May 8, 1992
LD-92-064

Document No. 52-002

Subject: System 80+TM Supplements to RAI Responses

THREE DIMENSIONAL MODEL
OF
STEEL CONTAINMENT

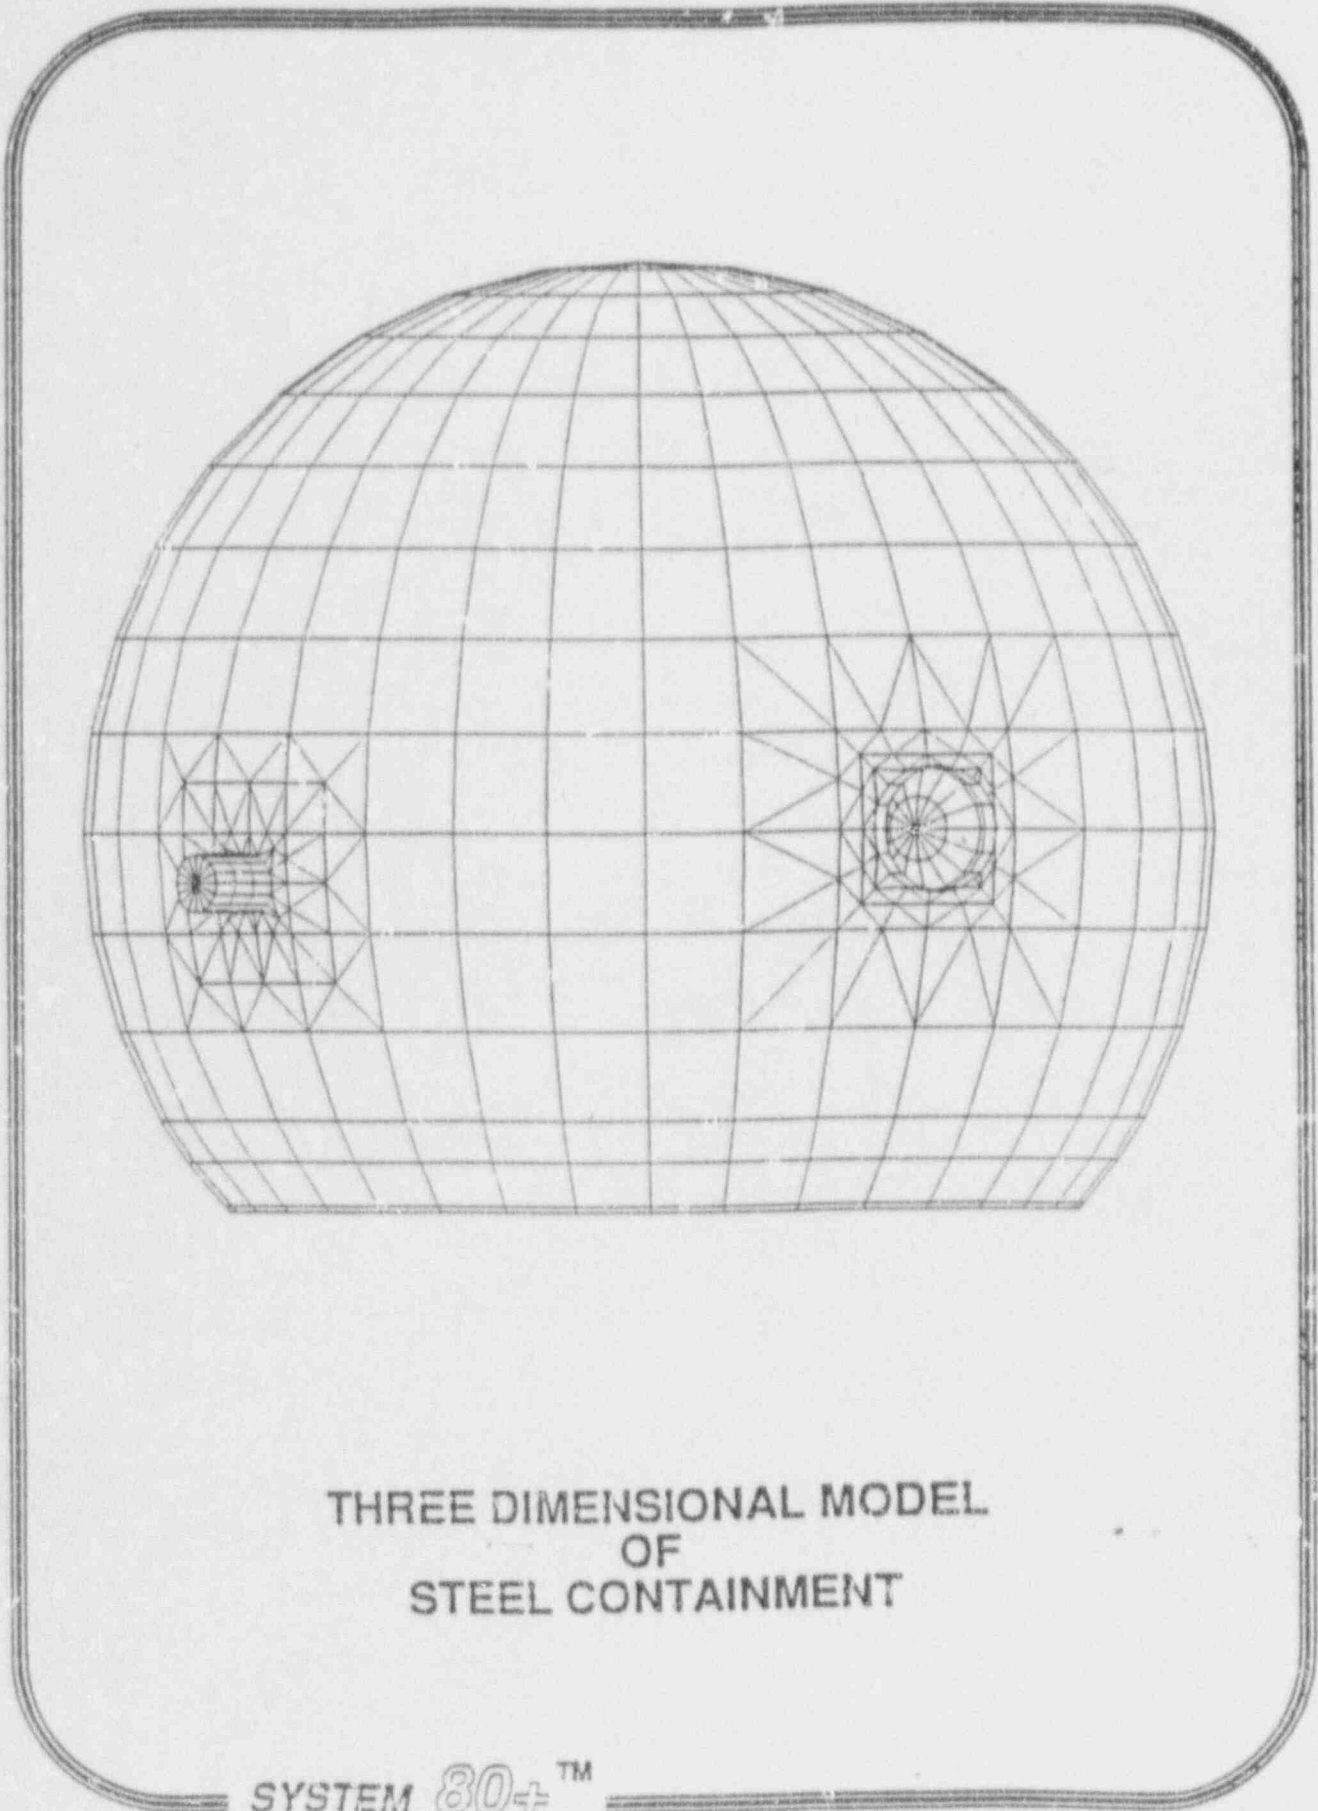
The NRC, Mr. Tom Cheng, has questioned the use of the ANSYS finite element type STIF63 which is used in the System 80+™ containment analysis. Mr. Cheng noted that the plot of the containment finite model had straight lines between the nodes and called Duke Engineering & Services (J.F. Snipes, J.T. Oswald and R.J. Pirlner) to ask if the elements are plate elements or shell elements. A plot of the model is included for information.

The ANSYS element type STIF63 is called an elastic quadrilateral shell element. It is actually a 4 node plate element with 6 degrees of freedom at each node, for a total of 24 degrees of freedom for each element. The element has both bending and membrane capabilities. An assemblage of these flat elements can produce a good approximation to a curved shell element surface provided that each flat element does not extend over more than a 15 degree arc. (Reference 1, pp. 4.0.22 and 4.63.2. A copy is attached.) The System 80+ containment model is generated with elements that do not extend beyond a 10 degree arc, with most elements closer to a 5 degree arc.

Isoparametric elements exist such as the ANSYS STIF93 element. This is an 8 node isoparametric shell element which is better suited to model shells. This is better suited because the element has an additional node between the corner nodes. These nodes may be located out of the plane of the element corner nodes. The element has a total of 48 degrees of freedom. The computer costs of running an analysis with this element is not justified when an analysis with the STIF63 quadrilateral shell is sufficiently accurate.

In general, the flat element is simpler to formulate and is a more cost effective method of analysis due to the fewer number of nodes and input required. The flat element by itself is limited in its ability to model shells because membrane and bending actions are uncoupled within the single element, simply because it is flat. The necessary coupling for the entire shell comes about because a membrane force in one element exerts an element normal force component on its neighbor. Thus, apart from requiring many elements to obtain accuracy, flat elements may display bending moments where there should be none.

A comparison of results using an 8 node isoparametric shell element and the ANSYS STIF63 element can be found in the ANSYS Verification Manual. (Reference 2, pp. C3.1-C3.2. A copy is attached.) The 8 node isoparametric solution is from Reference 3, Cook, pages 284-287. Both results are from elements which extend over a 20 degree arc. The stress results varied by only 0.6%. This is considered accurate enough to justify not using the much more costly isoparametric element for the System 80+ containment analysis.
